Access Compliance Report

Public Rights-of-Way

(Curb Ramps)

Intersection ID: 3215	Main Street: BELLMORE_CT	Cross Street: OLD_BRIDGE_LN	Location: SW
ADA ID: BE7BEE09D814	Ramp Type: Perp	Initial Pass/Fail: Fail	Overall Compliance: No
Severity Score: 37.5			
Codes/Mitigation Info/Possible Solution		Field Measurements/Component Compliance

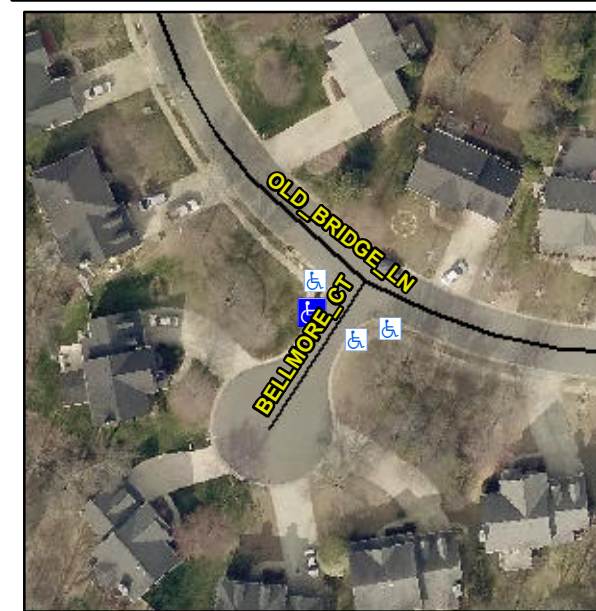
Not Found, R304.2.2, R304.5.3

Compliance	Description	Data	Compliance	Description	Data
N/A	Ramp Length (in)	45.0	No	Ramp Slope (%)	13.1
Yes	Ramp Width (in)	48.0	No	Ramp XSlope (%)	5.3
N/A	Flare Type LT	N/A	N/A	Flare Type RT	N/A
N/A	Flare Slope LT (%)	N/A	N/A	Flare Slope RT (%)	N/A
N/A	Flare Traversable LT?	N/A	N/A	Flare Traversable RT?	N/A
N/A	Landing Length (in)	N/A	N/A	DWS Provided?	N/A
N/A	Landing Width (in)	N/A	N/A	DWS Contrast?	N/A
N/A	Landing Slope (%)	N/A	N/A	DWS Length (in)	N/A
N/A	Landing X Slope (%)	N/A	N/A	DWS Full Width?	N/A
N/A	Landing Curb? (Y/N)	N/A	N/A	DWS Offset (in)	N/A
N/A	Shared Landing?	N/A			
N/A	Gutter Ponding?	N/A	N/A	Gutter Slope (%)	N/A
N/A	Gutter Lip Ht (in)	N/A	N/A	Gutter X Slope (%)	N/A
N/A	Painted X Walk1?	No	N/A	Painted X Walk2?	N/A
	X Walk 1 Direction	To SE		X Walk 2 Direction	N/A
N/A	X Walk 1 Width (in)	N/A	N/A	X Walk 2 Width (in)	N/A
	X Walk 1 Slope (%)	0.7		X Walk 2 Slope (%)	N/A
	X Walk 1 X Slope (%)	3.5		X Walk 2 X Slope (%)	N/A

Remove & Replace Entire Ramp.
